TECHNICAL DEFICIENCIES RESPONSE LETTER

June 10, 2024

***Re: Technical Deficiencies Responses for the Phase IV Pipeline
DEP Joint Permit File No. E4129223-006 / APS No. ID No. 1096604***

LEGEND

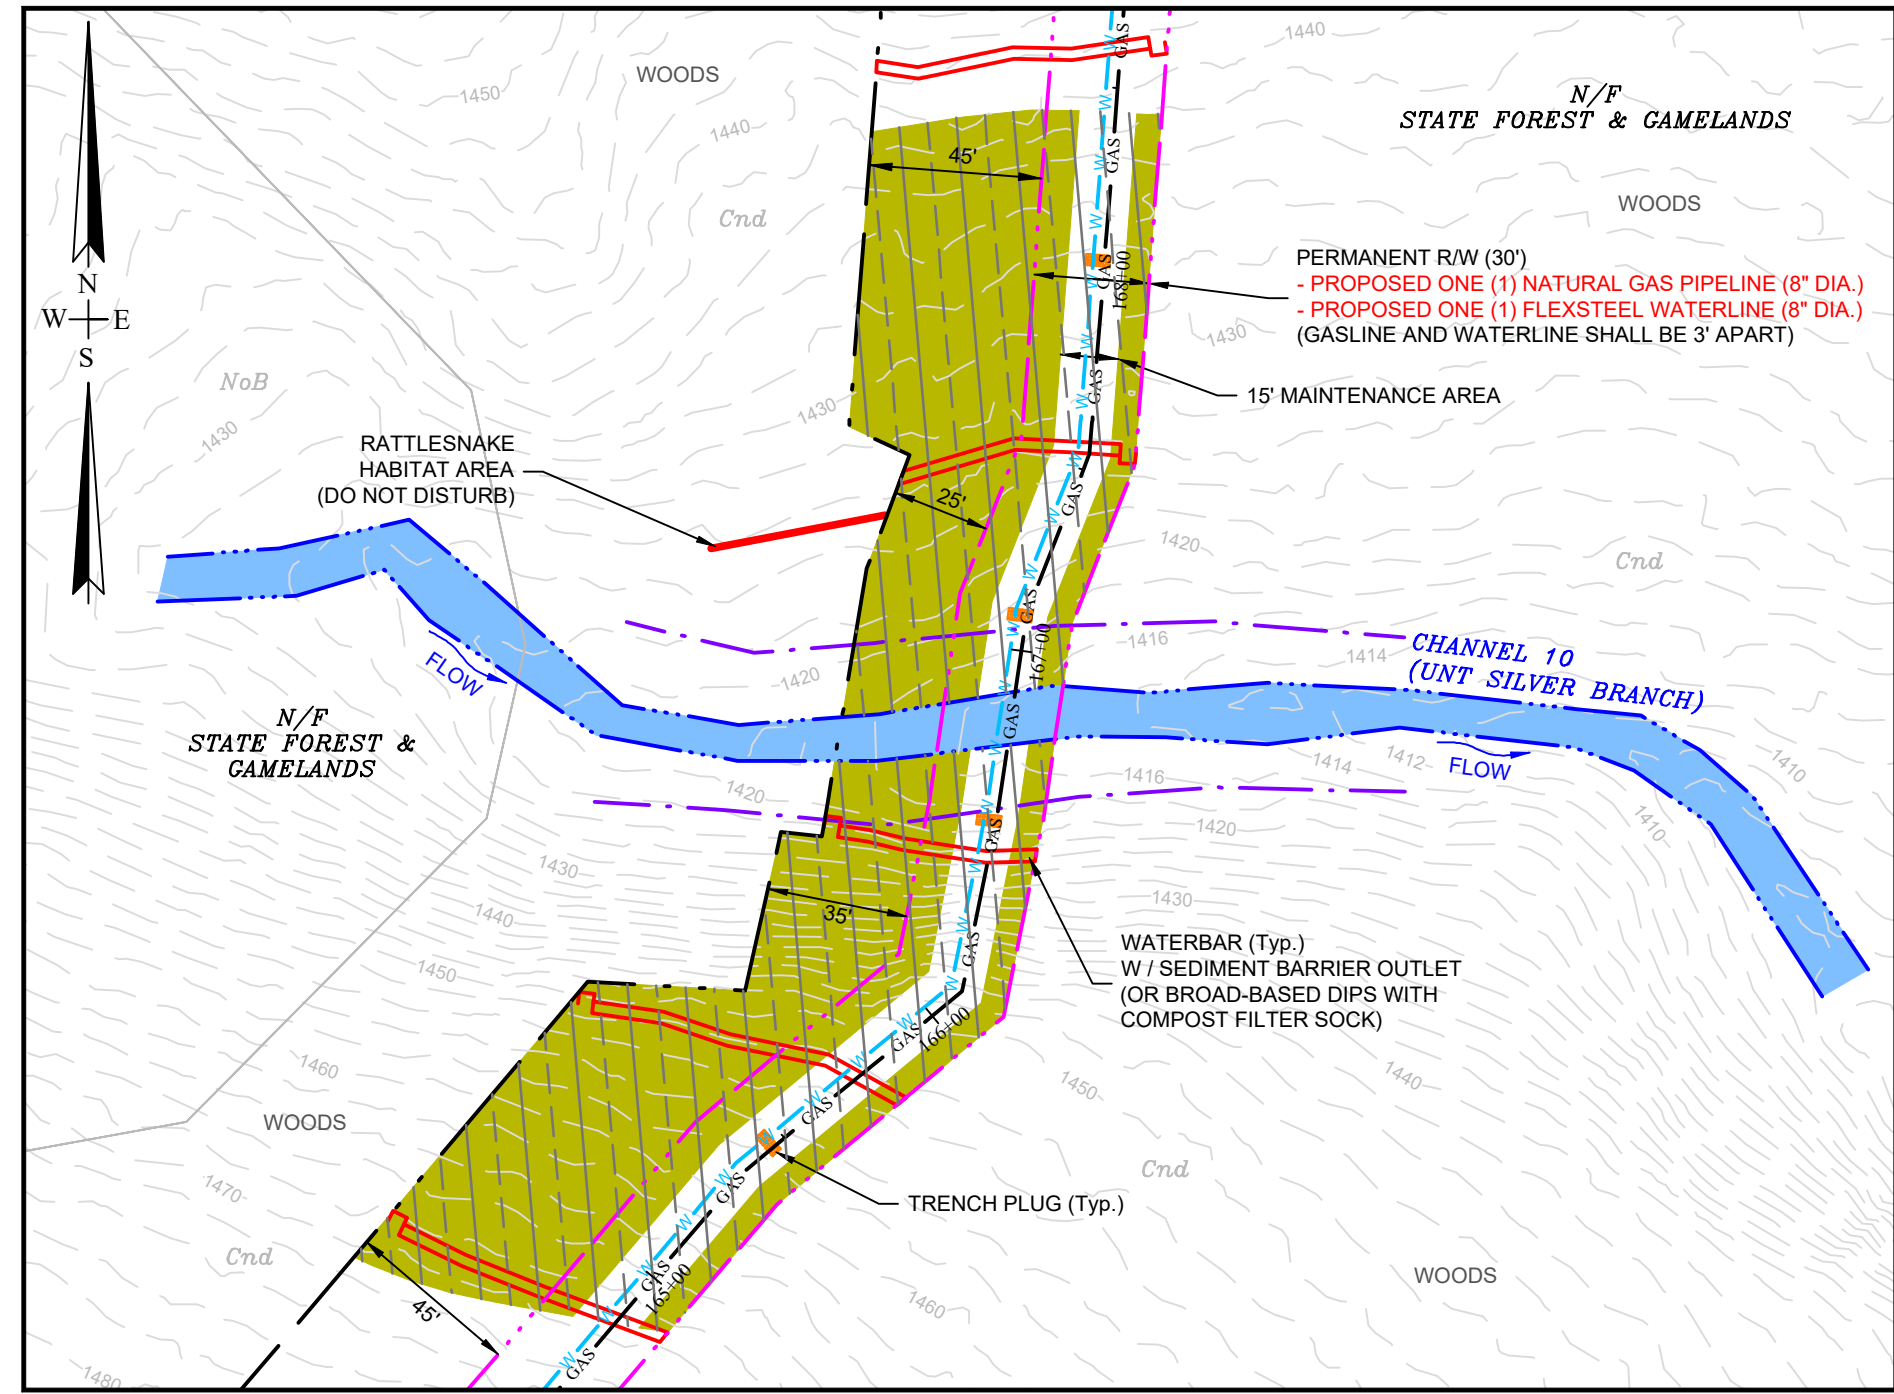
2. Provide protective measures (e.g.- tree tubes, fencing, enclosures, etc.) for proposed tree and shrub plantings (wetland and riparian areas) to help promote success and survivability. 105.13(e)(1)(ix)

The protective measures have been added to the notes on the Wetland & Riparian Buffer Planting Plan Sheets 2 & 3.

- Where local conditions warrant, these dates may be extended with the owners approval.
 8. To help promote success and survivability for proposed tree and shrub plantings (wetland and riparian areas), use protective measures such as tree tubes, fencing, enclosures, etc..
